### **OFFICIAL NOTICE AND AGENDA**

Meeting:	ZONING BOARD OF APPEALS
Members:	Nancy Hoffmann, David Burke, Mark Dillman, Dave Oberbeck, Jerry Jarosz, Nan Giese (Alternate), Arlene Kaatz (Alternate)
Location:	Council Chambers at City Hall, 407 Grant Street
Date/Time:	Wednesday, March 15, 2023, at 4:00 p.m.

## **STAFF REPORT**

### Subject: Variance for Athletic Lighting at East High School

LIGHTING CONTROL AND MONITORING CABINET. PRECAST POLE BASE AND LIGHT POLE.

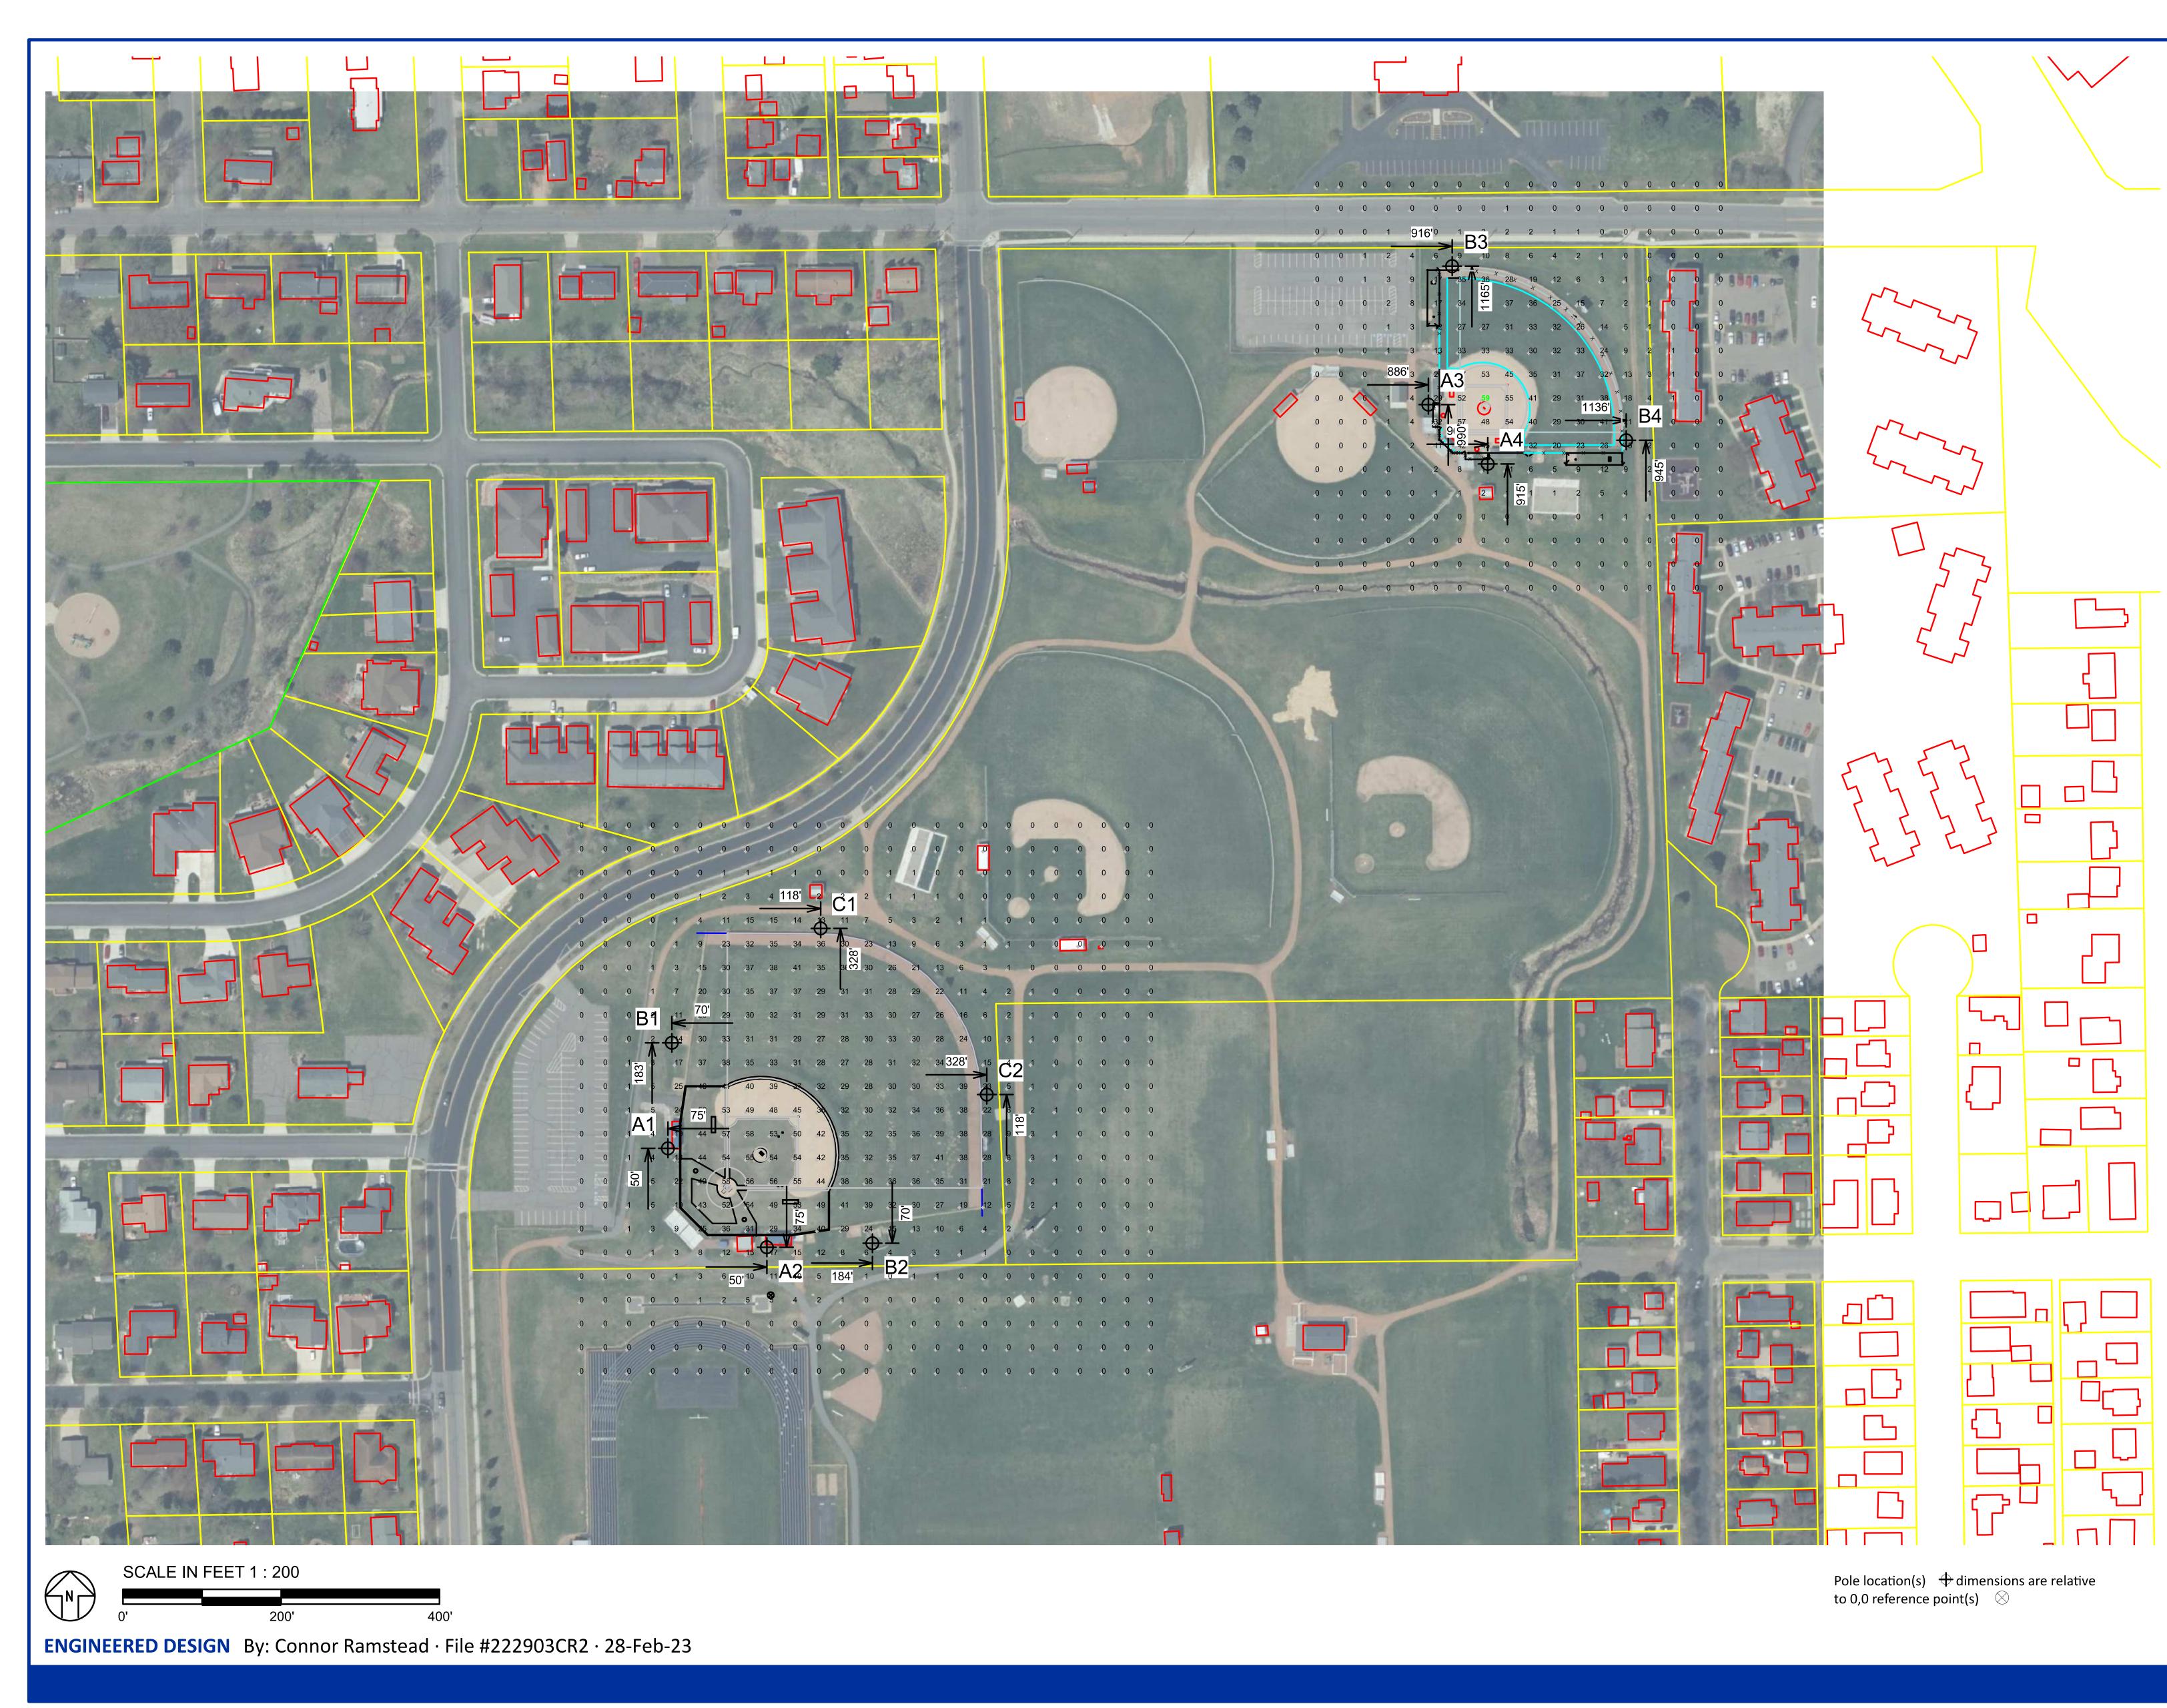
In your packet you will find plans showing the lighting pole height and distance to property lines. Poles that need a variance are clouded around and show pole height and distance to property lines. Also, photometric lighting plans have been included showing that no light spillage will occur over the property lines.

Engineered plans show no light spillage at the property line. The right-of-way at Stevens Drive is larger than a typical city street, 78 feet wide versus 60 feet. That does give a little more separation from the light poles to the neighboring homes along Stevens Drive.

The softball field does have some tight setbacks to the property lines. The pole height being proposed helps to reduce the number of poles that would need to be placed and it is designed to allow for adequate lighting for the athletes to play safely. This field is immediately adjacent to a parking lot serving the field and the field is served by a press box.
